ADDENDUM 02

Project:
New 2 Story Classroom Building
Rogers Middle School
Lawndale, CA 90260

WW Project No. 22029.01
DSA Application No. 03-123867
File No. 19-57
Owner:
Lawndale Elementary School District
4110 W. 154th St.
Lawndale, CA 90260

SHEET NO:
G101

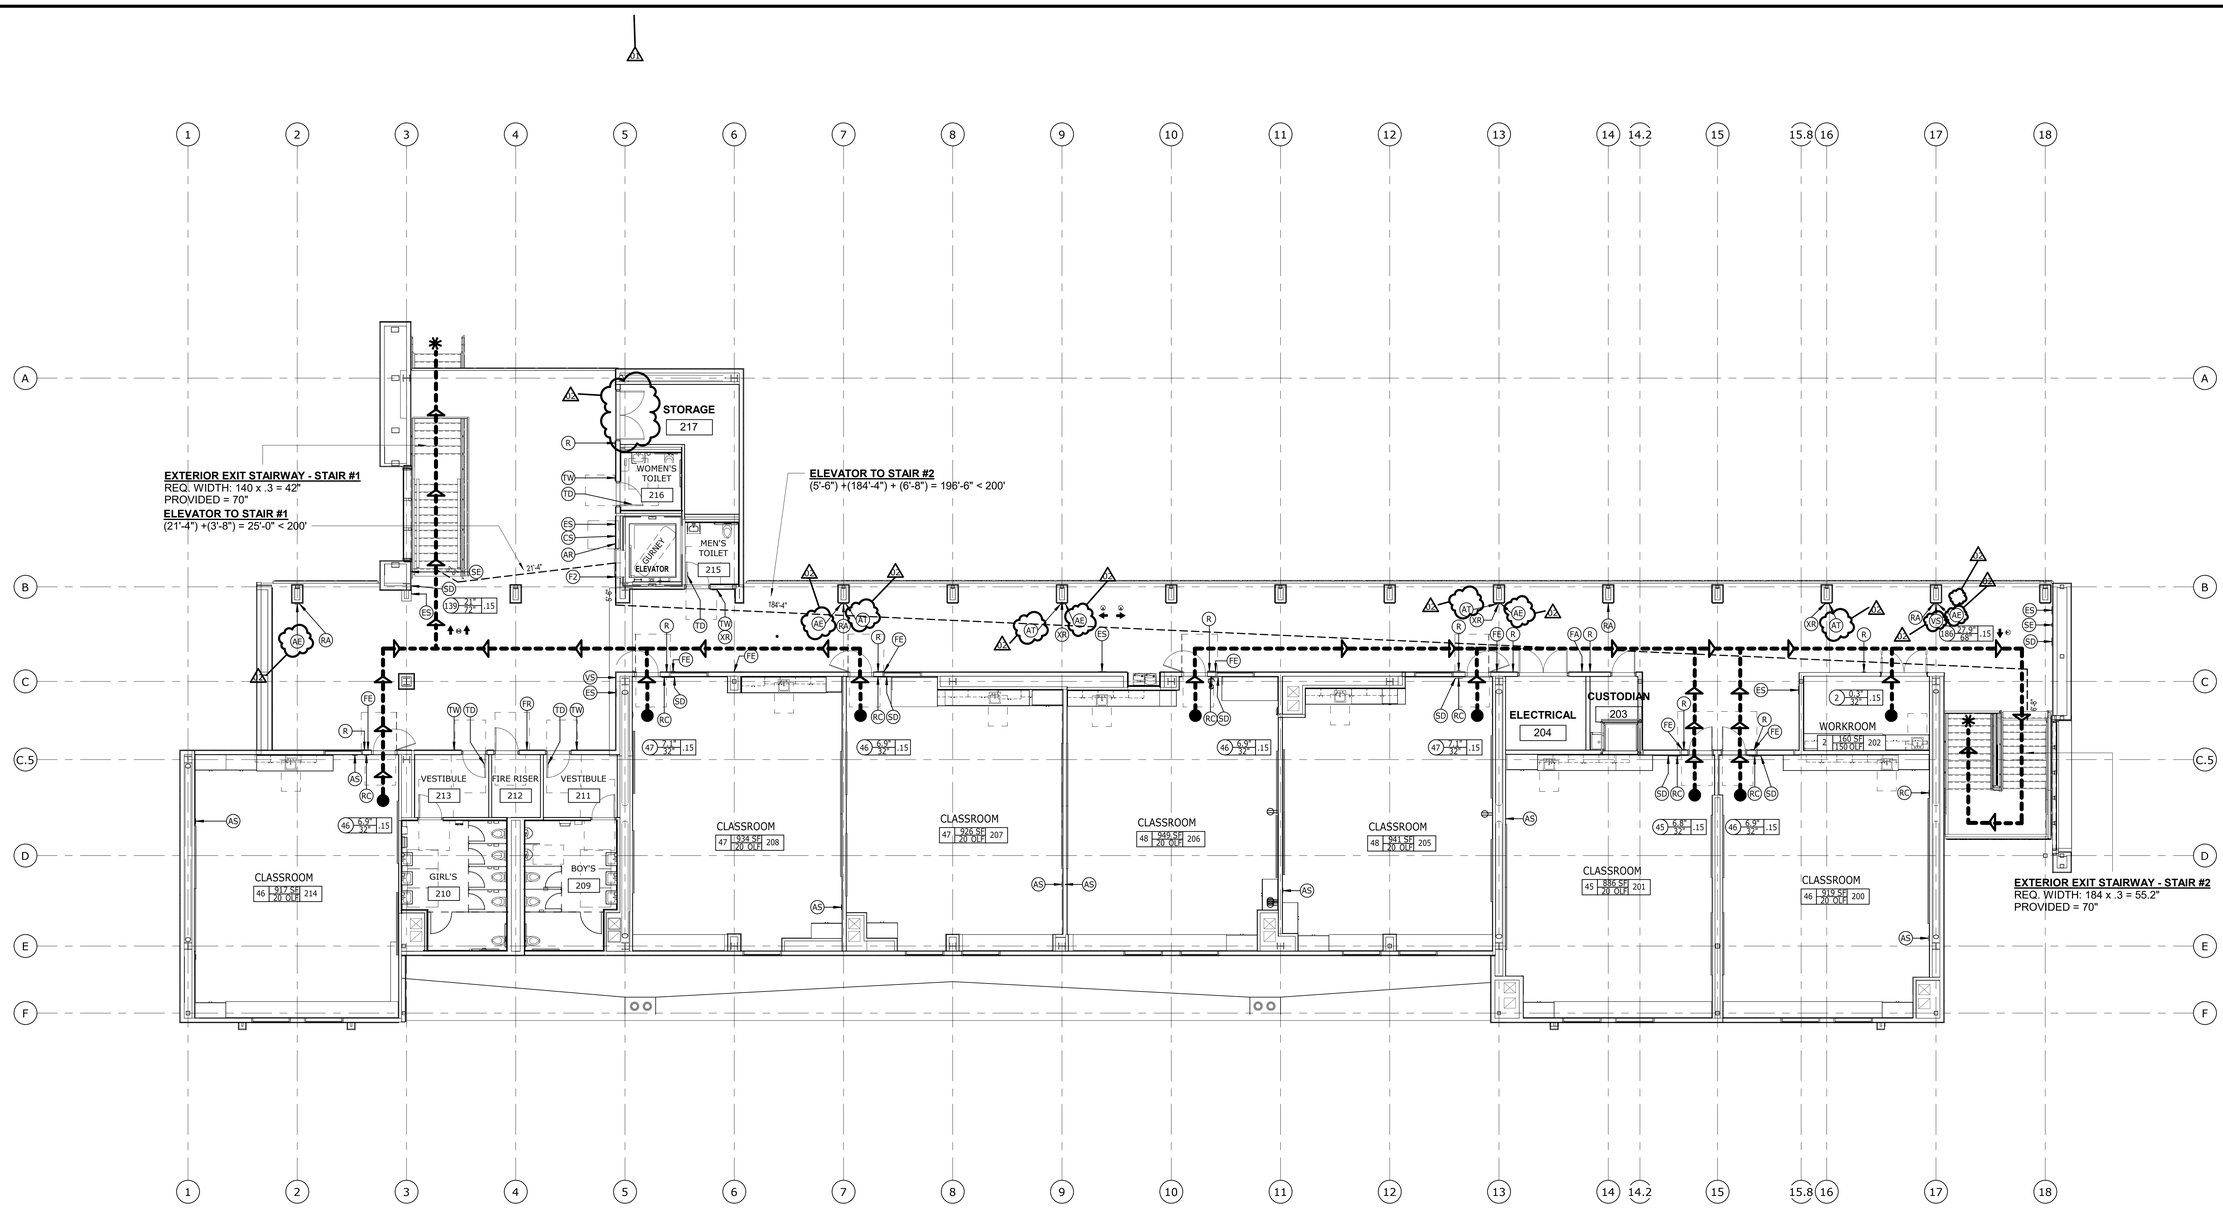
6.3 **Question:** Archico Design Build RFI #4
   Should sign legend 'XR' in sheet G101 and G102 reference detail 5K/G002 in lieu of 5B/G0042?

SHEET DESCRIPTION:
SITE CONTROL PLAN - PHASE 1

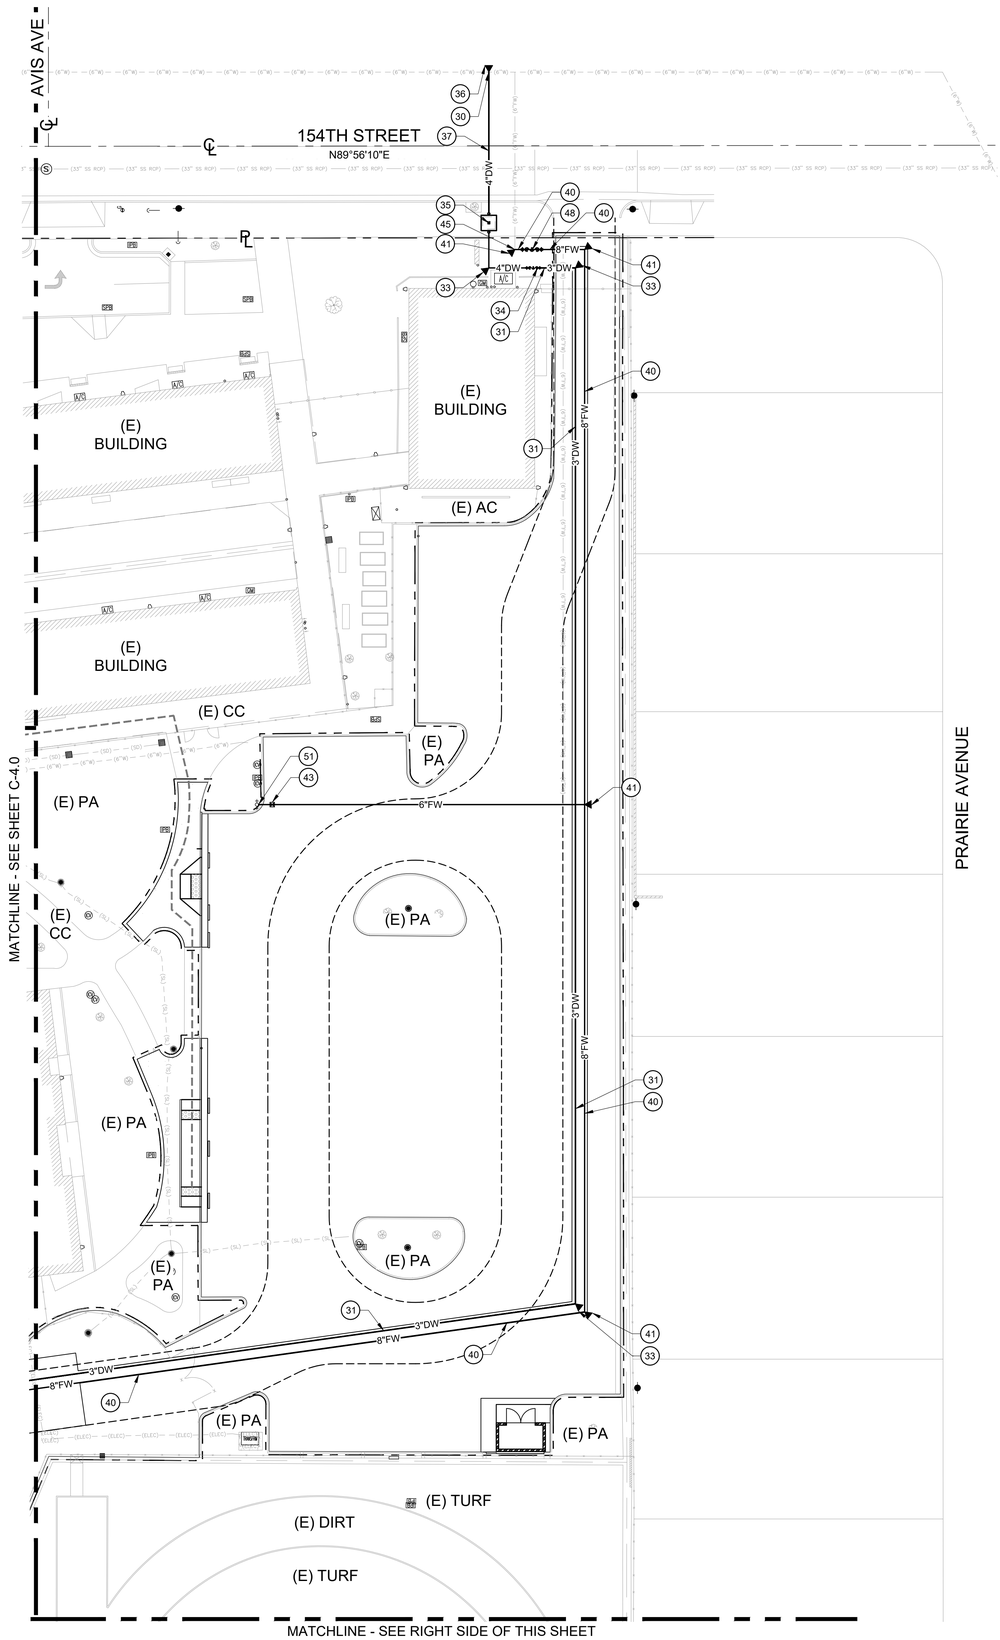
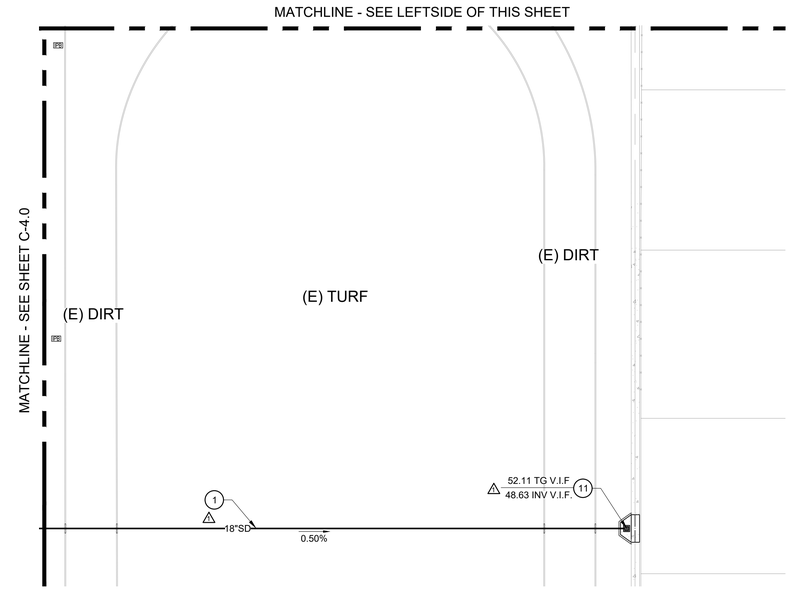
Please clarify thickness of asphalt concrete in existing asphalt paving assembly per sheet C-2.0 and C-2.1 Construction Note #30.

A. C-2.0 & C-2.1 Construction Note #15 referenced detail 2&4/A005 for fence and gates detail. Would detail 10 & 11/A007 be the fence and gate details instead? Please also provide fence height(s) and gate size(s).
B. C-2.1 shows new pair vehicular gates. But CD-1.1 Protect-In-Place Note #40 shows this pair gate is existing. Please clarify which governs.

Construction Note 30 on Sheets C-2.0 and C-2.1 refers to Detail 1 on Sheet C-5.2. As shown in Detail 1/5.2, for trenching in paved areas, the existing pavement shall be replaced with the same material, with the thickness increased by 1" over the existing.

A. Reference detail from Note 15 on Sheet C-2.1 has been changed to note 10, 11 and 15/A007 of architectural drawings.
B. Vehicular gate to be protected in place

A301

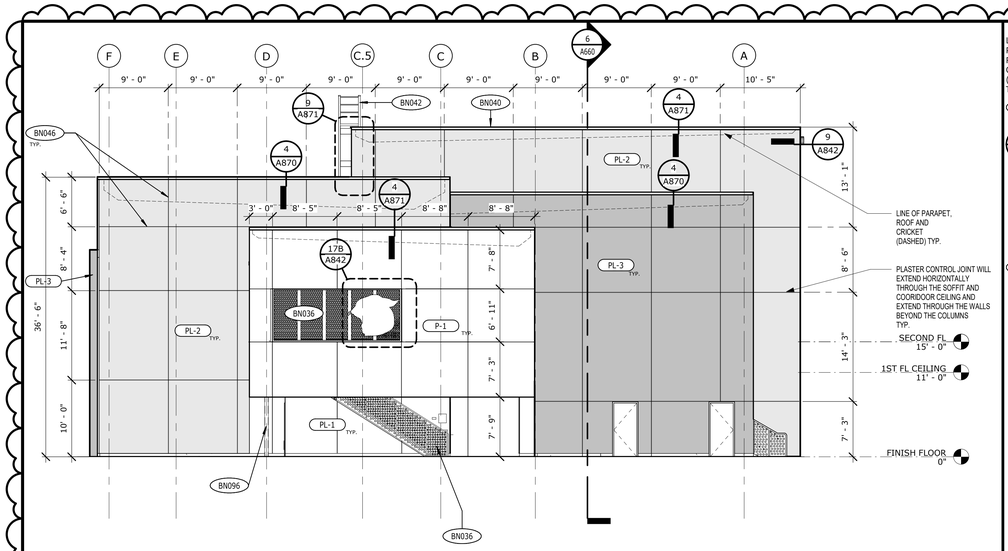
a) Mechanical tie offs have been located on the plans. See construction note BN087 "PROVIDE TIE OFFS PER DETAIL 14/A870".
b) Keynote BN083 has been added to designate the mechanical units.
c) Mechanical units, split conditioning units and exhaust fans have been located on the plans with dimensions.
d) BN088 has been added to the project to provide a new roof hatch per 9/1870.
e) BN092 has been added to locate the new split air conditioning system.
f) BN094 was added to designate the new walkway pads on the plan.
g) Walkway pads have been added to the plan.

6.27 **Question:** Archico Design Build RFI #28
Please clarify width and route of roof walkway pads per Specification 2.03. It is not shown on sheet A301.

SHEET NO:
A401

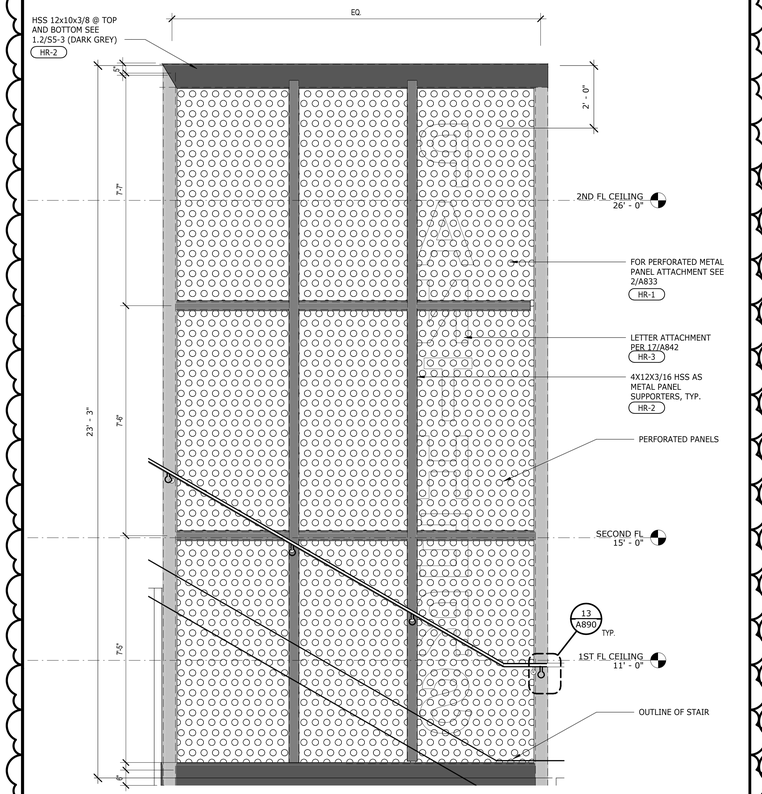
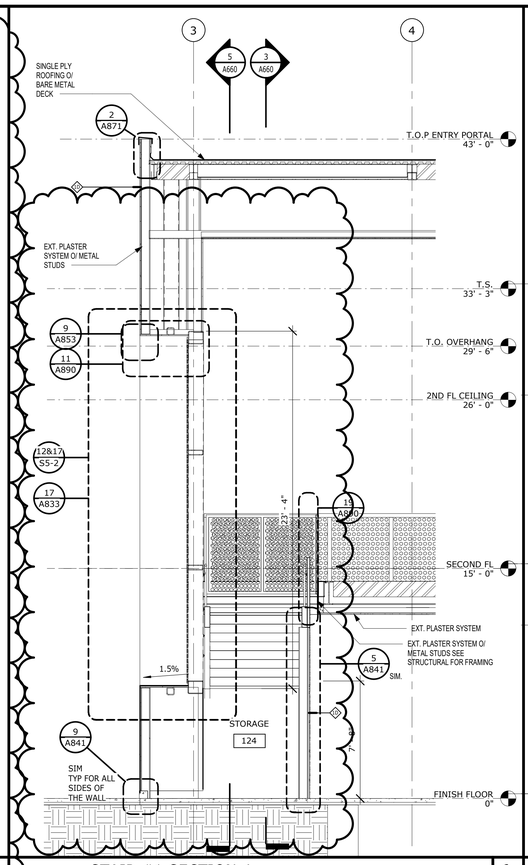
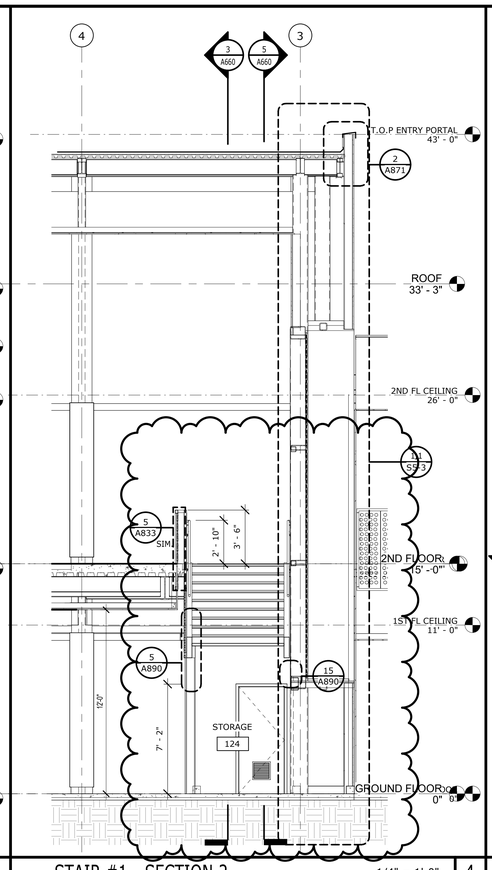
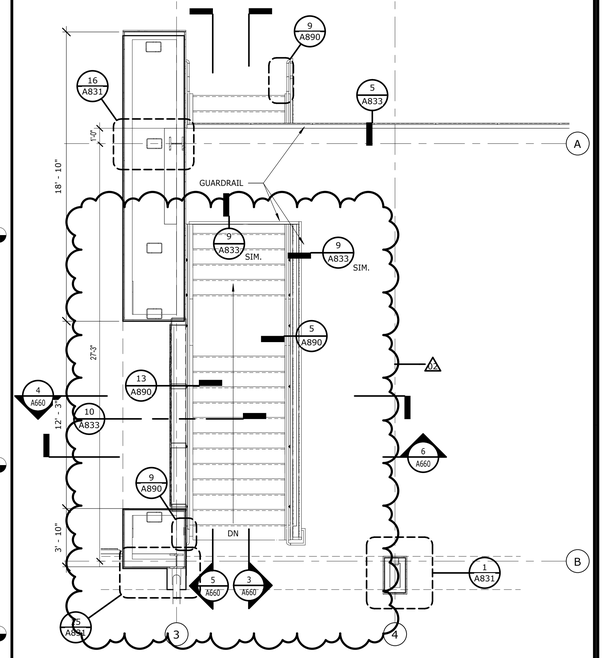
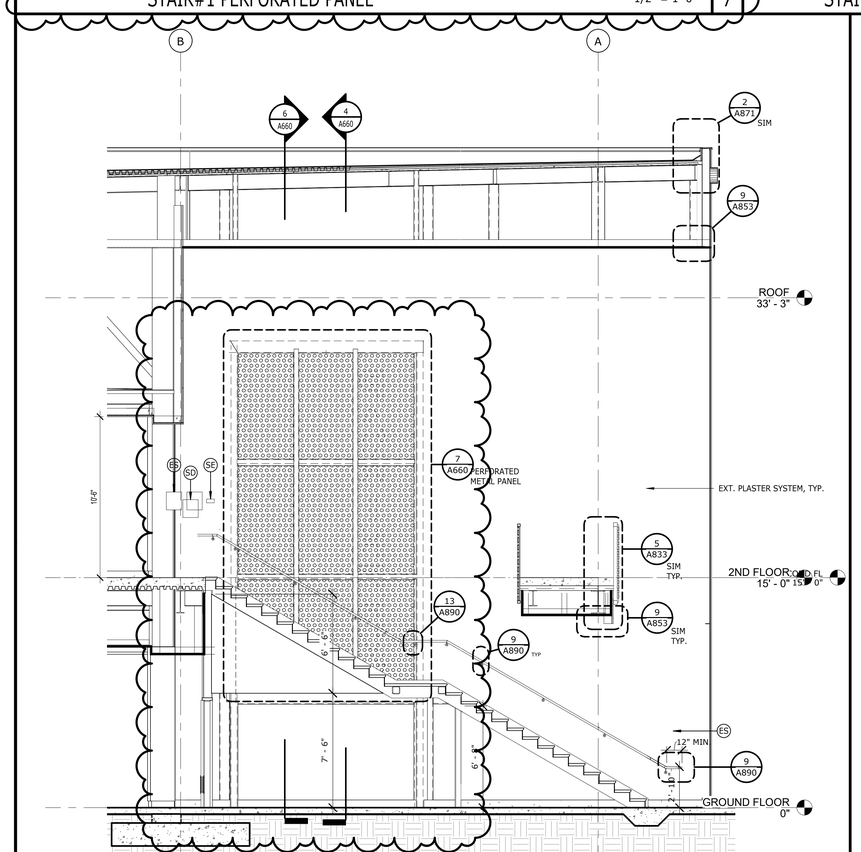
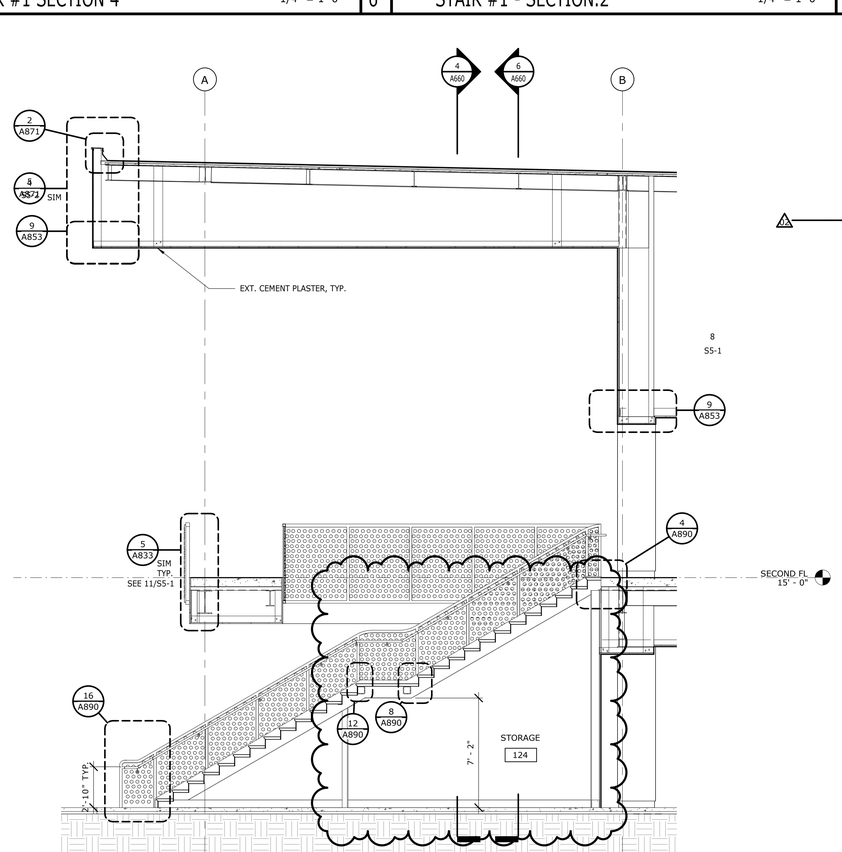
a) New storge room has been added underneath the stair in detail 1. Dimensions wall tags and details has been added. Details 2,3,4,6 and 5 has been revised accordingly to show the new storage details and elevations.
b) Detail 7 will have new HSS sizes to create a new frame that does not include the picture frame that was in the original approve drawings. See structural for more information.

STORAGE ROOM AT STAIR 1 1" = 1'-0" 10

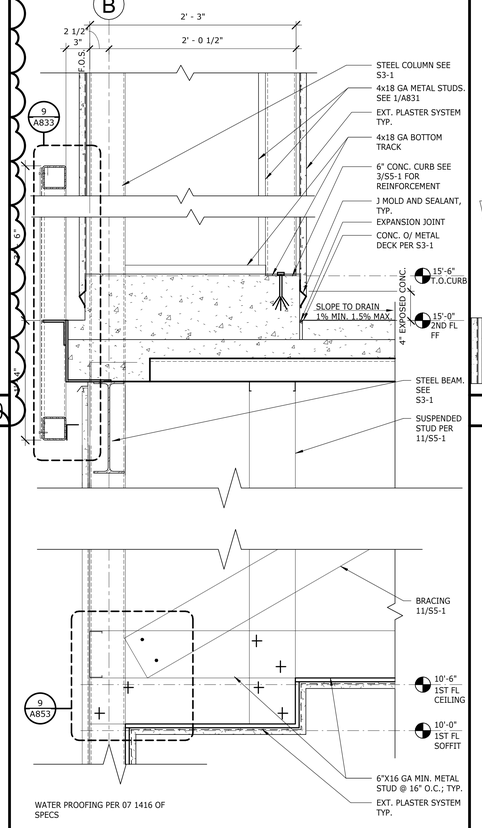
a) Detail 10 added to show the water proofing elements at the storage rooms at stair 1.
b) Detail 13 was added to show the jamb condition where the opening at the stairs occurs.
c) Detail 14 was added to show the finishes around the opening @ stair #2.
d) Detail 17 was added to show the finishes around the opening at stair 1.

11B: SPLIT AIR CONDITIONING CURB AND CONDENSER

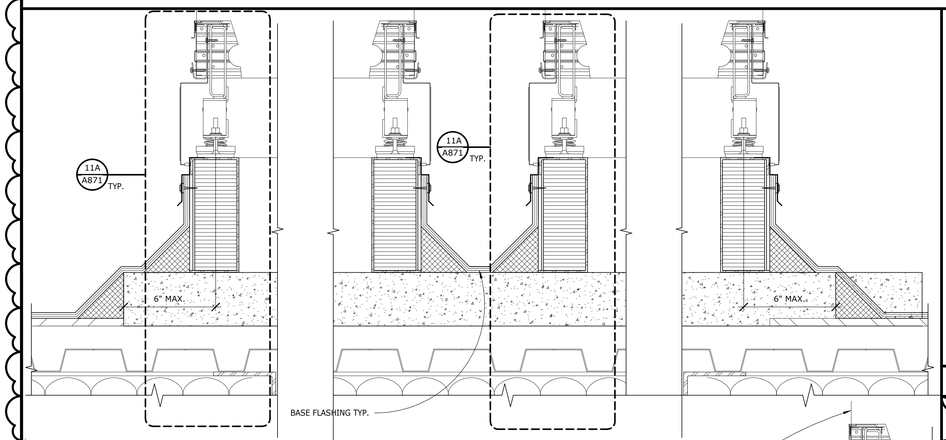
a) Concrete condenser has been added to the detail therefore the flashing and cant strip has been modified to accommodate for that.
b) Detail 11B has been added to show the condition where 2 split air conditioning units sit on a single concrete condenser.
c) Detail 9 has not been modified only moved to create more space for detail 11.
